TECHNICAL SERVICE BULLETIN

Illuminated MIL And/Or Powertrain Malfunction (Wrench) Indicator With Various Diagnostic Trouble Codes (DTCs)

25-2385

Ford
2022 e-Transit

Figure 1

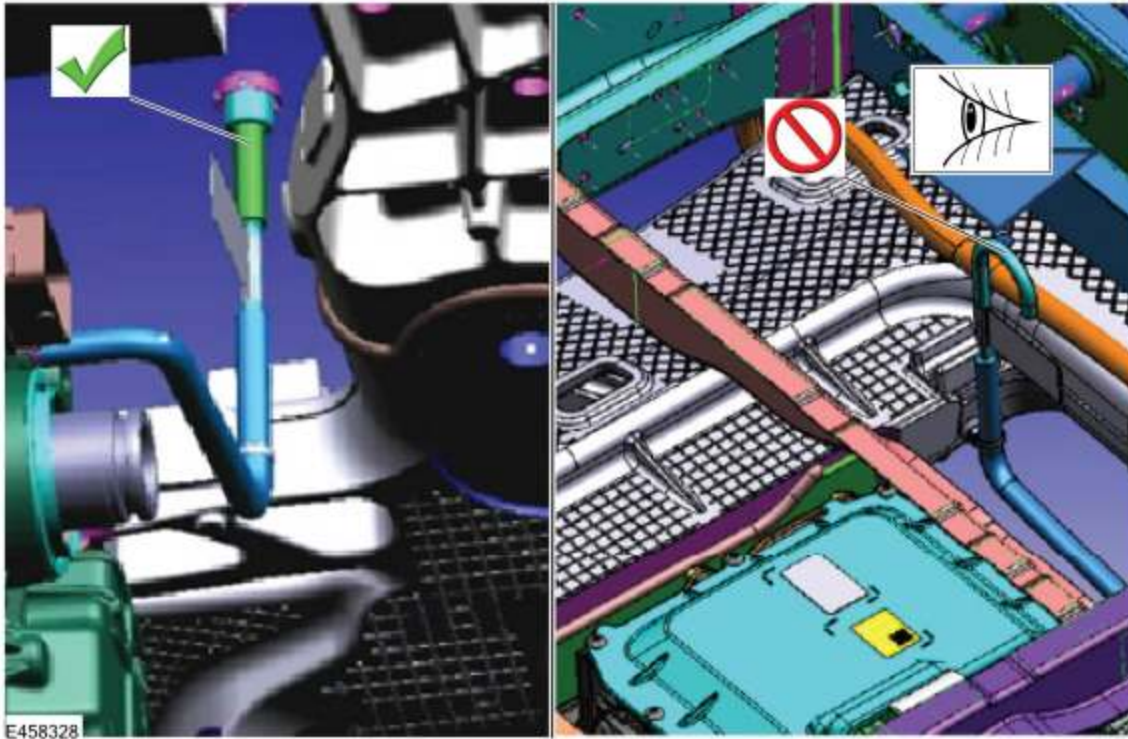
- Illuminated MIL and/or illuminated powertrain malfunction (wrench) indicator with DTCs P0711, P0A2B, P0A2D, P0A2C, P0712, P0713 stored in the SOBDMC.
- DTCs P0AA6, P1A10 stored in the IPC
- Equipped with early design vent assembly attached to rear electric drive assembly. Refer to Figure 1.

1. Raise vehicle to inspect the rear electric drive assembly unit vent. Refer to WSM, Section 100-02 > Jacking and Lifting.
2. Is the vehicle equipped with the rear electric drive assembly vent hose as shown in the image with the green check mark in Figure 1?

- (1). Yes - proceed to Step 4.
 - (2). No - proceed to Step 3.
3. Remove and discard the vent tube assembly and replace with updated part.
 4. Perform the "Drive Assembly Oil Draining and Filling". Refer to WSM, Section 302-02 > General Procedures.
 5. Clear DTCs.
